REALARCHITECTURE LTD
2899 N. Speer Blvd. Suite 102
Denver, Colorado 80211
www.realarchitecture.com

August 31, 2020

The following letter and revised drawings respond to your review and comments for 53rd and Tennyson Row project at 4301 W. 53rd Ave, Log number PRC2020-00005. Responses are listed below in **red**. Please call or email if you have any questions or require additional information.

SITE PLAN
SCALE: 1:20

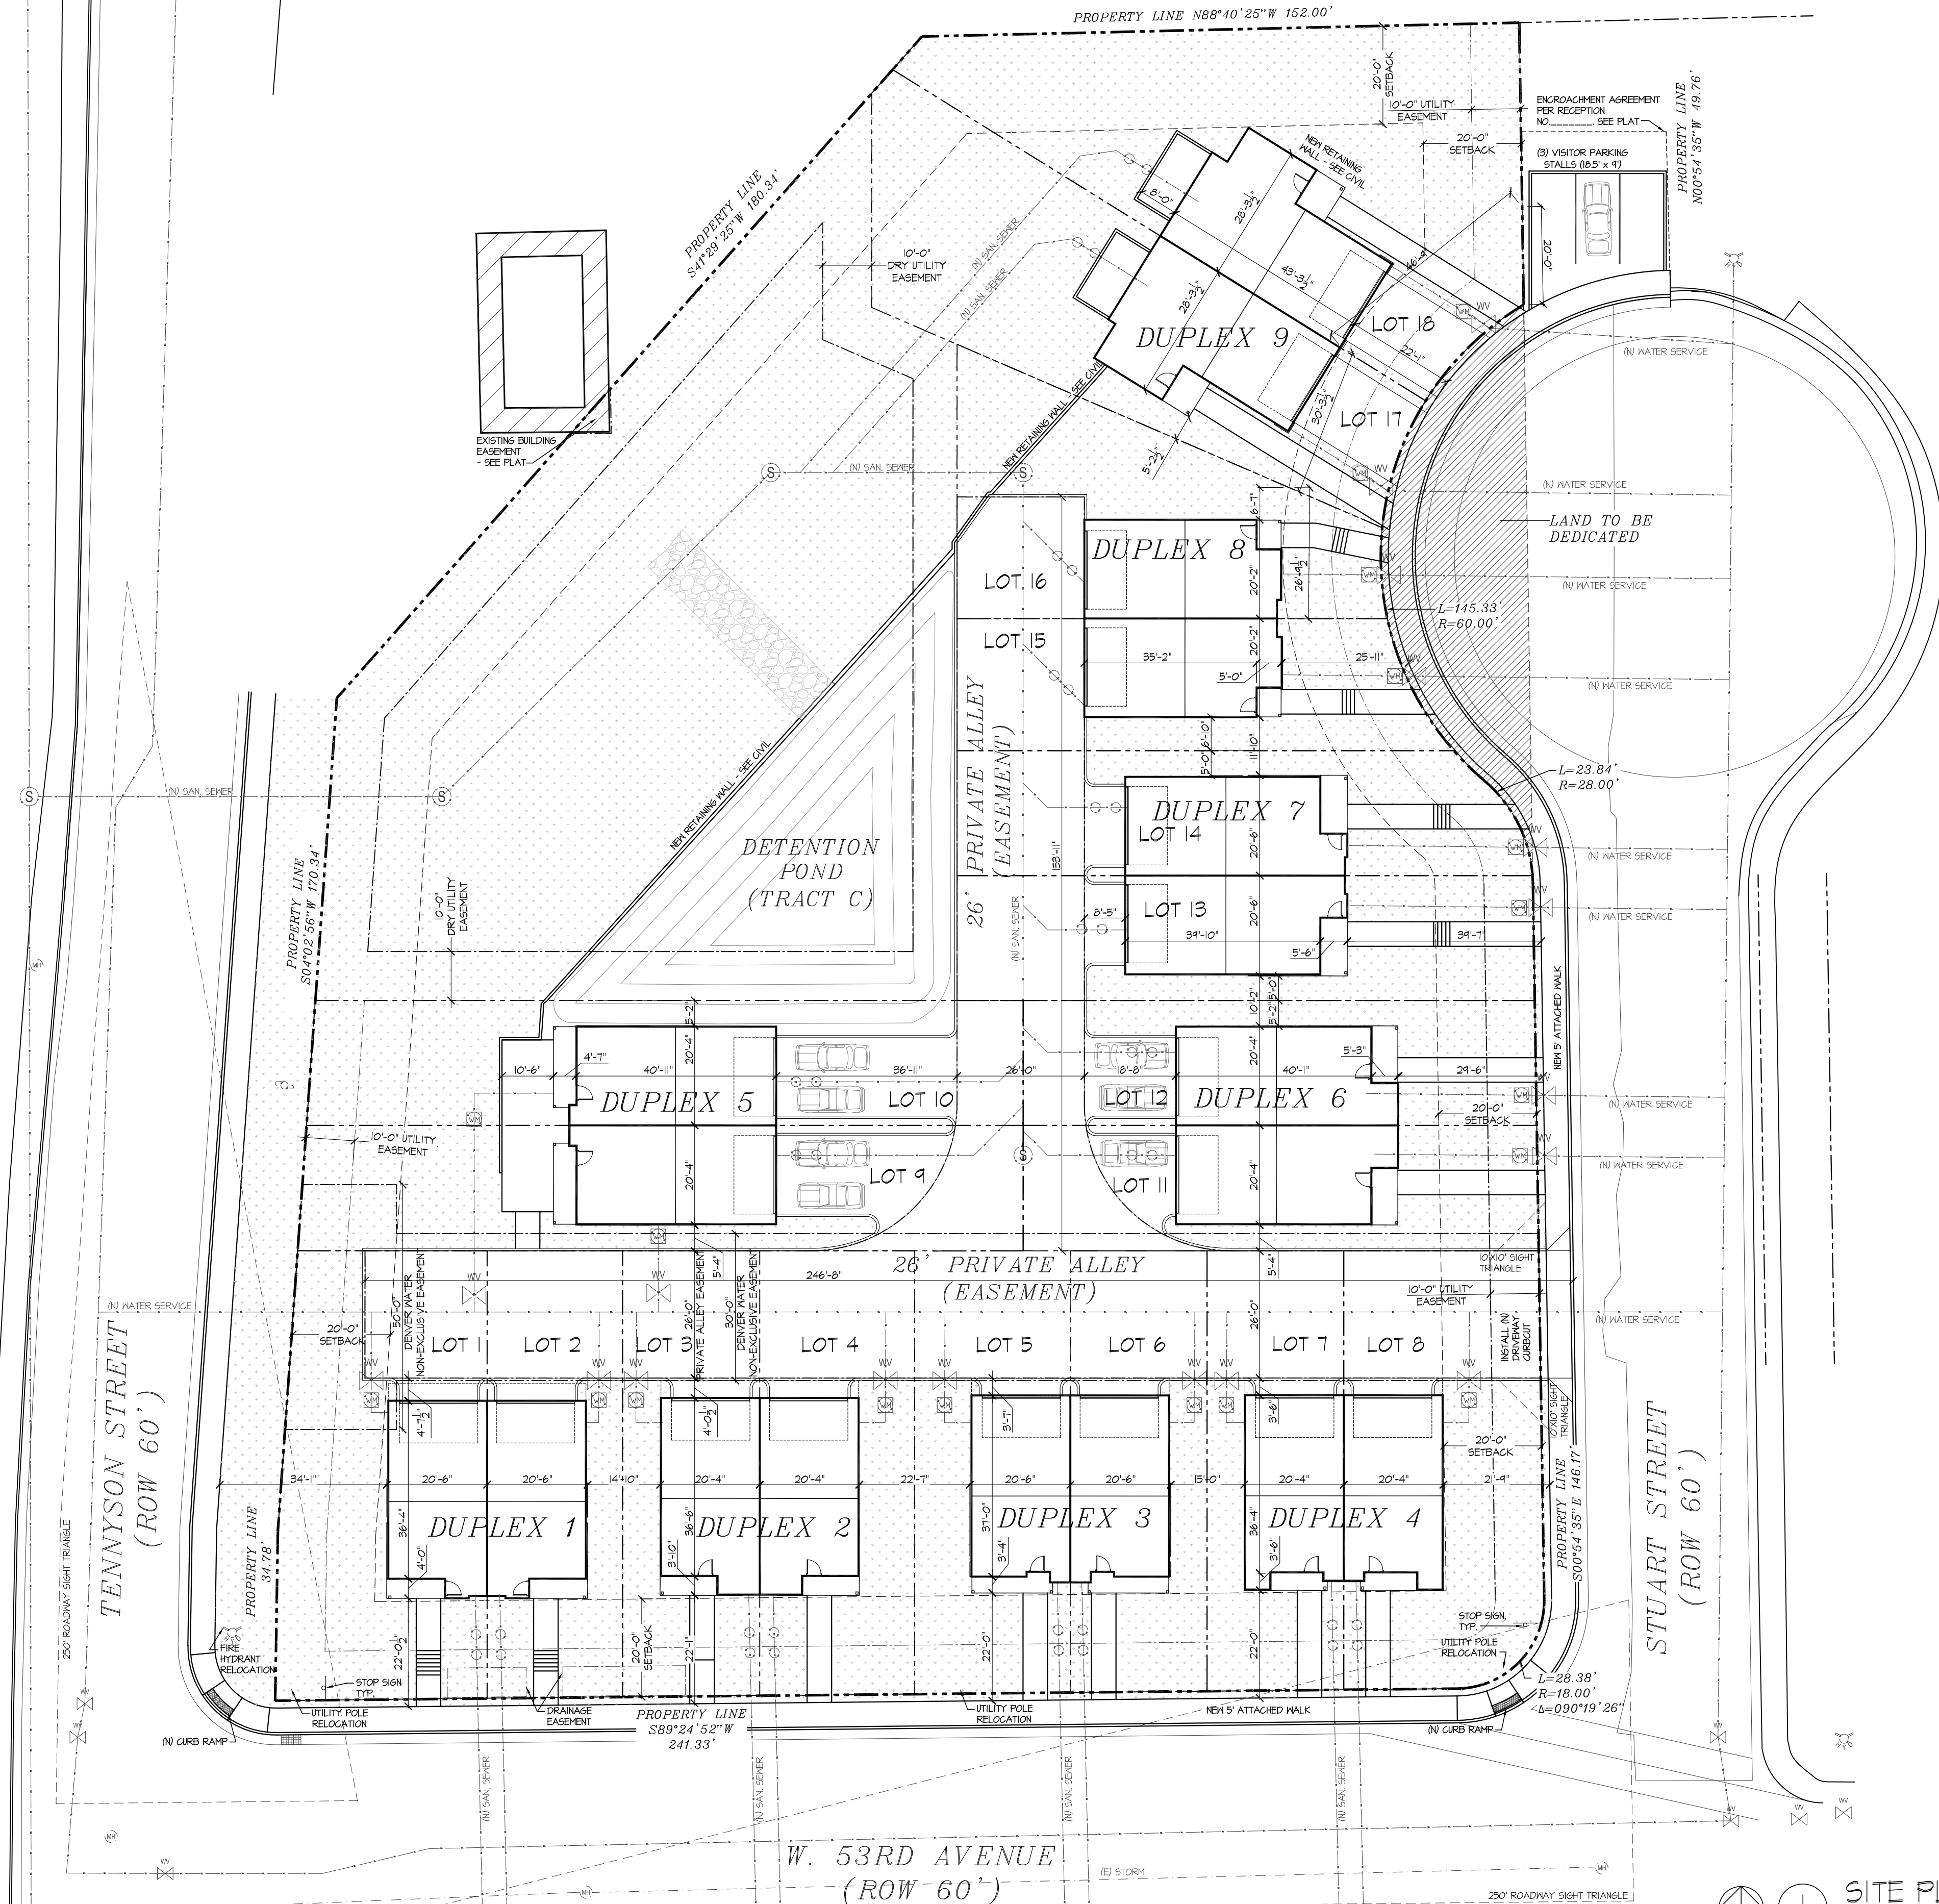
1. Please label front lot widths for Lots 16,17, and 18 on the site plan (northeast Lots 4, 5 and 6 on the Plat). Lot width for wedge-shaped lots are measured at the front setback line (20 ft. depth), and must be at least 25 ft. in width in the R-3 zone.

Response:
Reference to City of Denver has been removed from the legal description on the site plan.
3. Please label setback Duplex 8 to north. All other setbacks have been labeled.

The front lot width as measured from the 20' front setback is dimensioned on Lots 16, 17 and 18. The Site Data Table has also been revised to reflect the dimensioned widths.

Response:
The side setback to the north from Duplex 8 is dimensioned on the site plan.
4. Architectural Standards/Project Compatibility, Section 4-07 Residential Use Performance Standards review:

A PORTION OF THE NORTHEAST ONE-QUARTER OF SECTION 18, TOWNSHIP 3 SOUTH, RANGE 68 WEST OF THE 6TH P.M.
COUNTY OF ADAMS, STATE OF COLORADO.
SHEET 1 OF 2

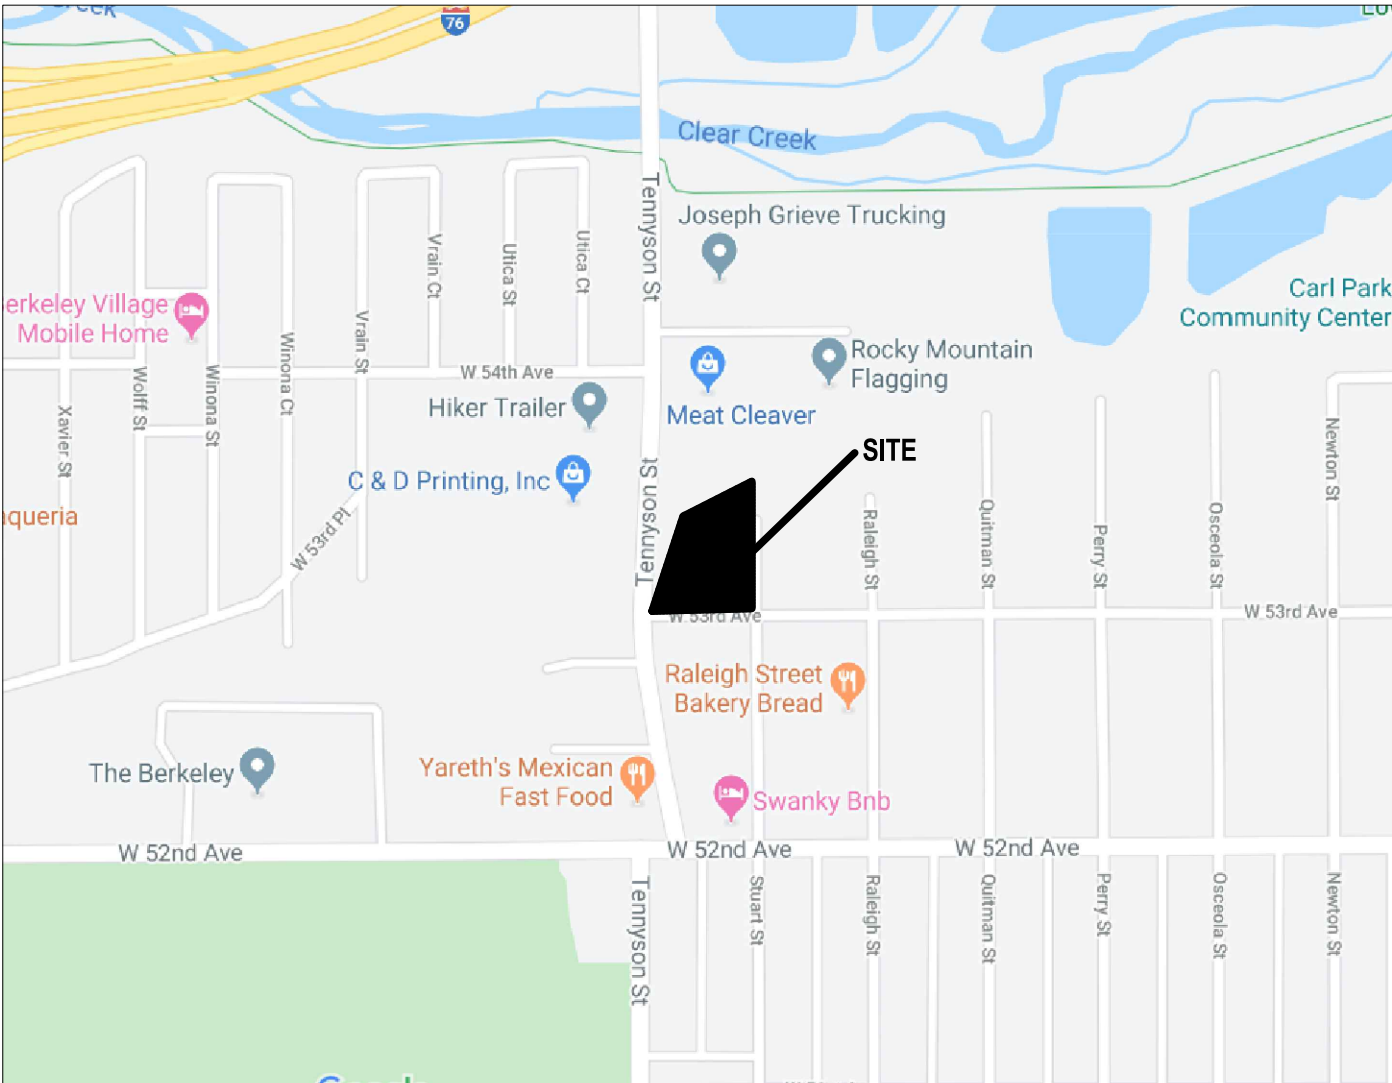
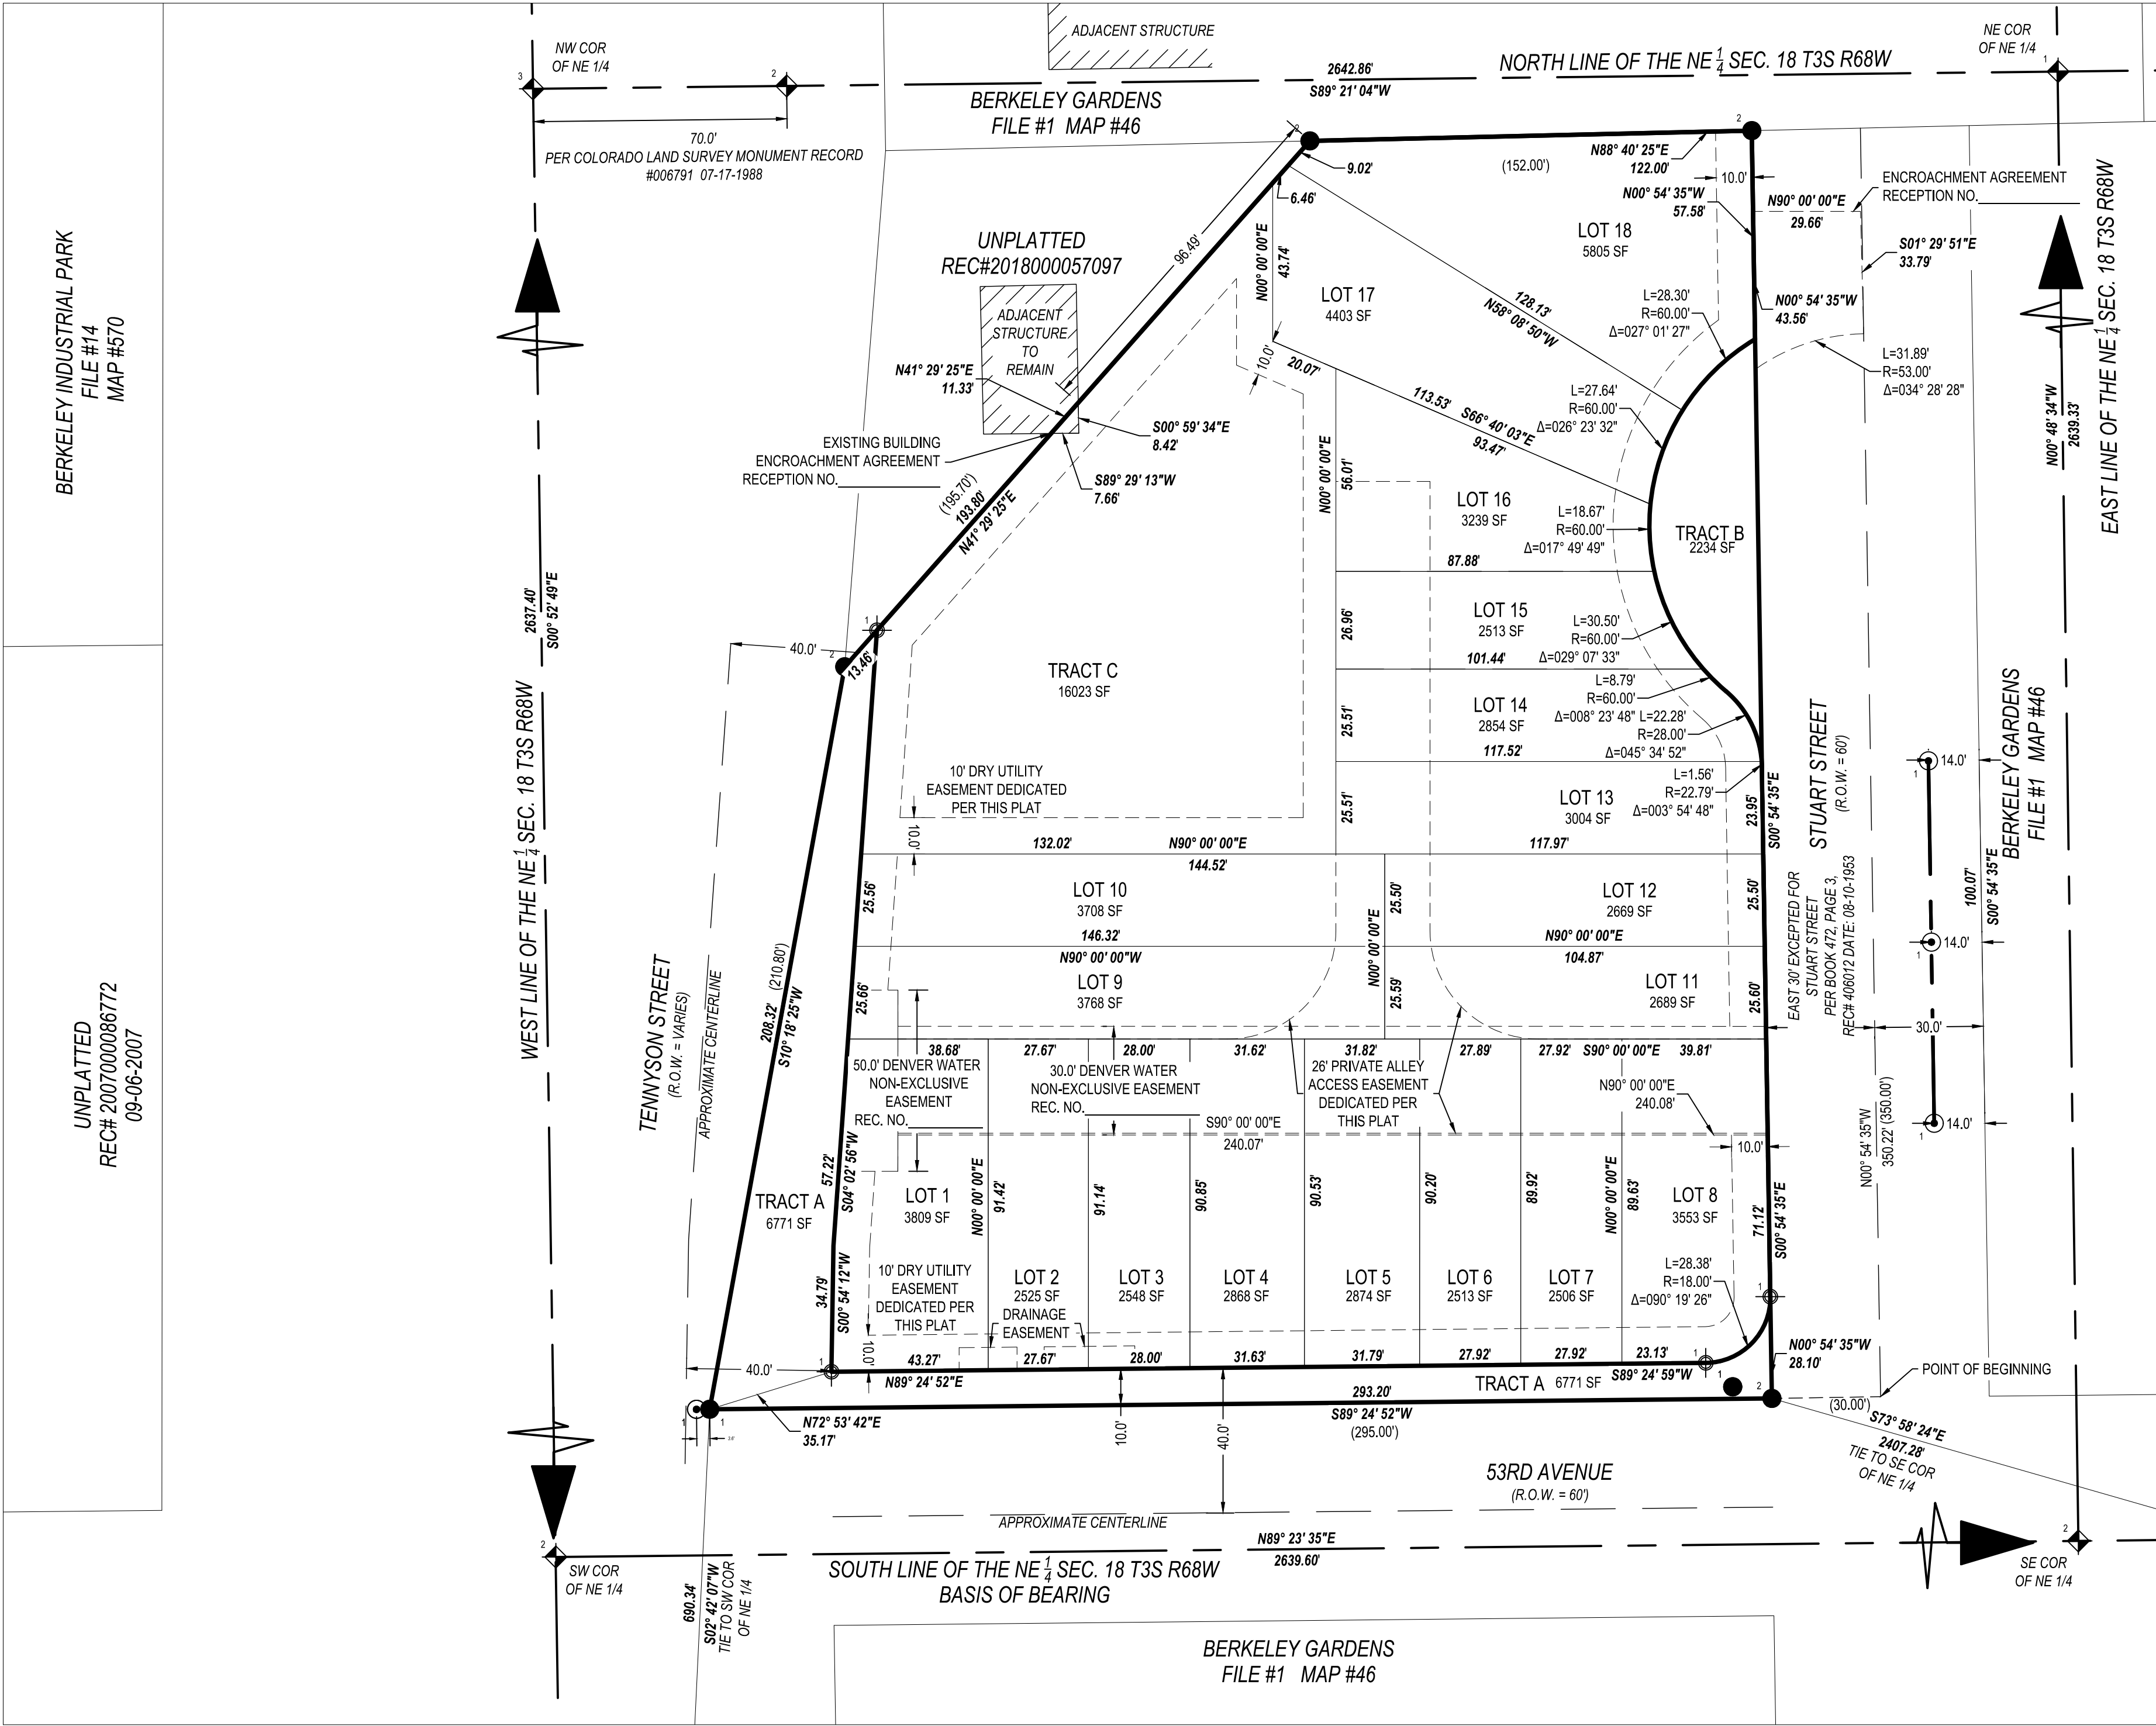
Please add case number PRC2020-00005 to top right corner of Sheet 1 & 2.

The case number has been added to the top right corner of sheet 1 & 2.
